SUBJECT: Forwards Rev 5 to response to NUREG-0737, Supp 1. Proposed date for submitting Reg Guide 1.97 repts changed from May 1984 to Sept 1984.

Subject: Duke Power Company  
Oconee Nuclear Station  
Docket Nos. 50-269, -270, -287

Response to Supplement 1 To NUREG-0737  
Document Revision Transmittal

Revision Number 5

FIGURE 2-2  
 OCONEE NUCLEAR STATION  
 UNITS 1, 2, 3

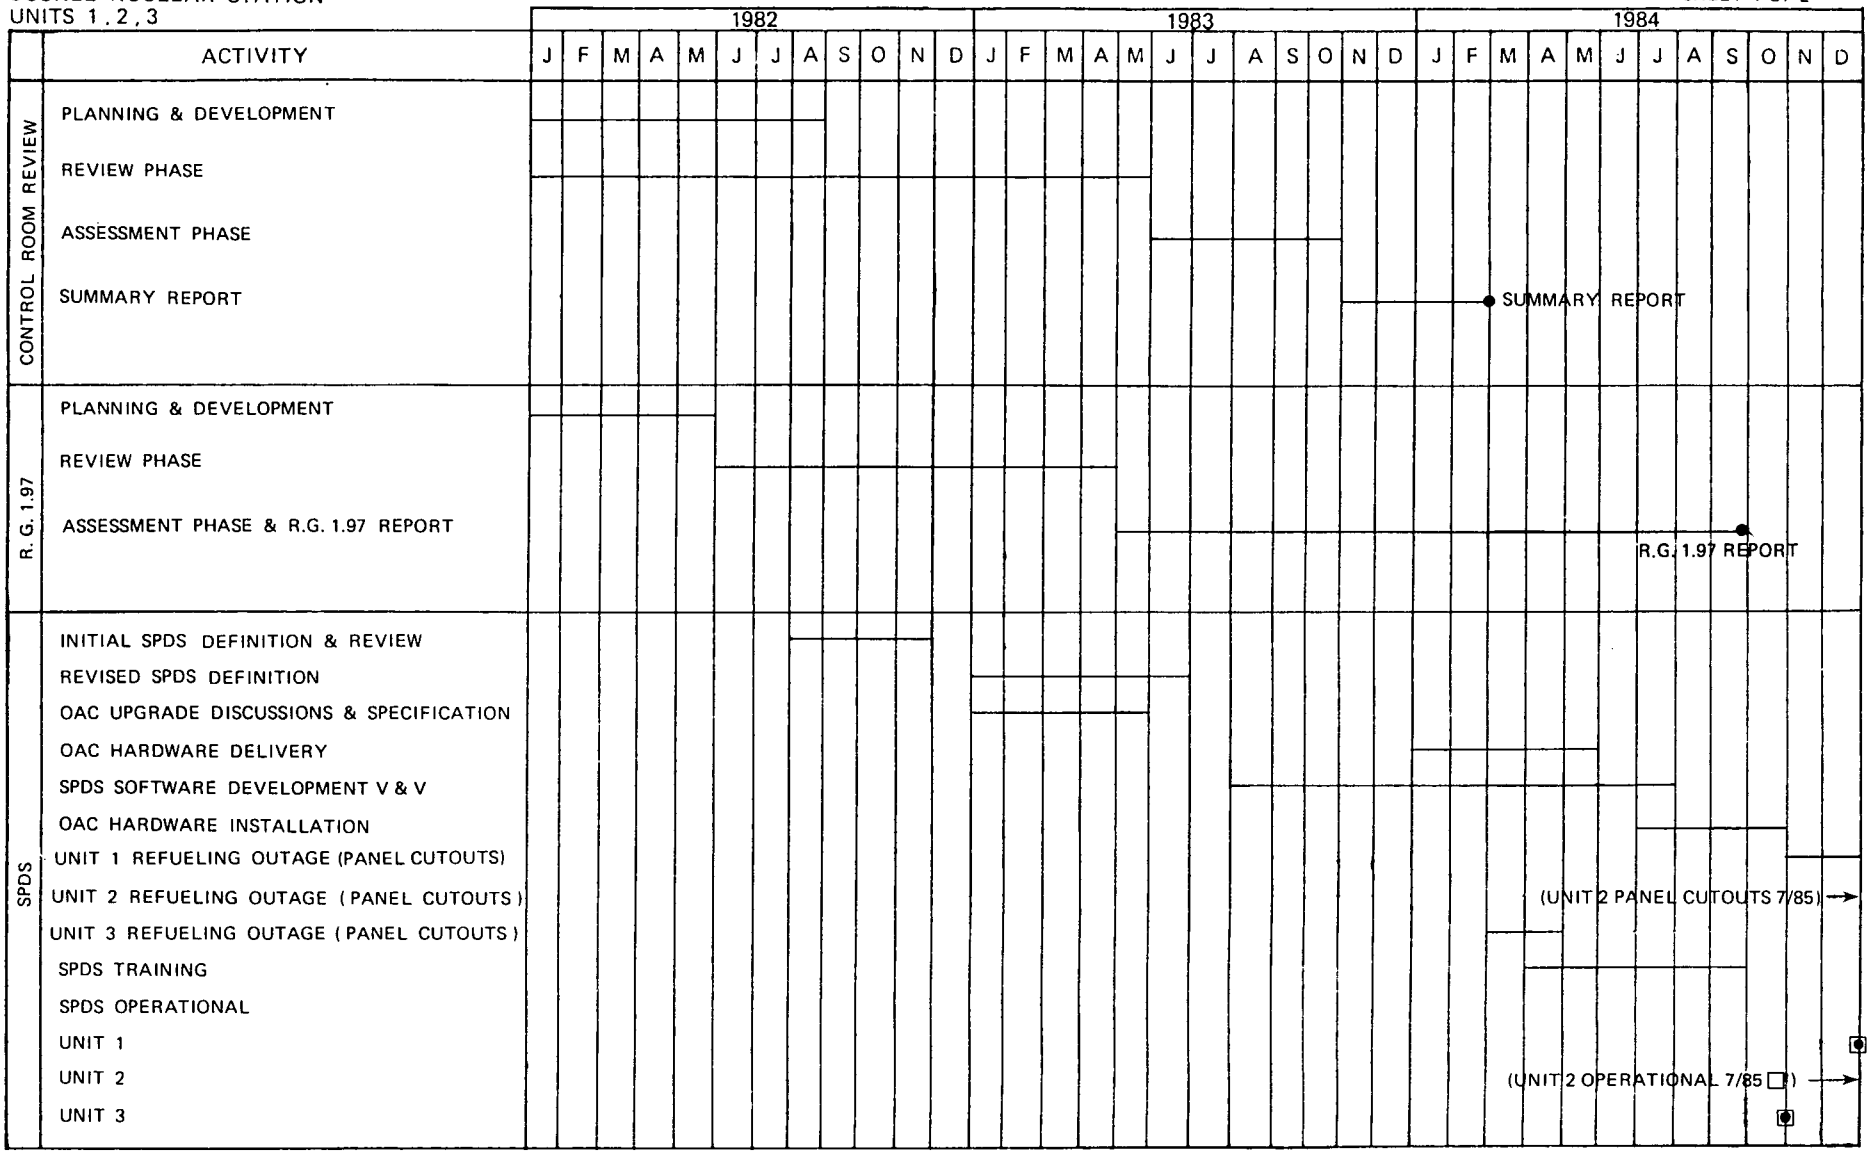
Revision 5 consists of a proposed change to the commitment date for submitting the Oconee Nuclear Station Regulatory Guide 1.97 Report from May 1984 to September 1984. It is requiring much more time and resources than originally estimated to retrieve and evaluate the information pertaining to the present design and develop options and schedules for the implementation of potential upgrades. Consequently, a four-month extension of time is needed to complete the study.

Insert Figure 2-2, Revision 5

Milestone Activity	Completion Date
Regulatory Guide 1.97	
o Review Plan Development	January, 1982
o Formal Review Plan Established	June, 1982
o Review Phase	May, 1983
o Assessment Phase	May, 1984
o R.G. 1.97 REPORT	SEPTEMBER, 1984*
Upgraded EP Program	
o Plant Specific Technical Guideline Development	December, 1983
o Plant Specific EP Development	October, 1984
o Verification and Validation	March, 1985
o Training	September, 1985
o IMPLEMENTATION, UNITS 1, 2, 3	OCTOBER, 1985*
UPGRADED METEOROLOGICAL SYSTEM OPERATIONAL	MAY, 1984*
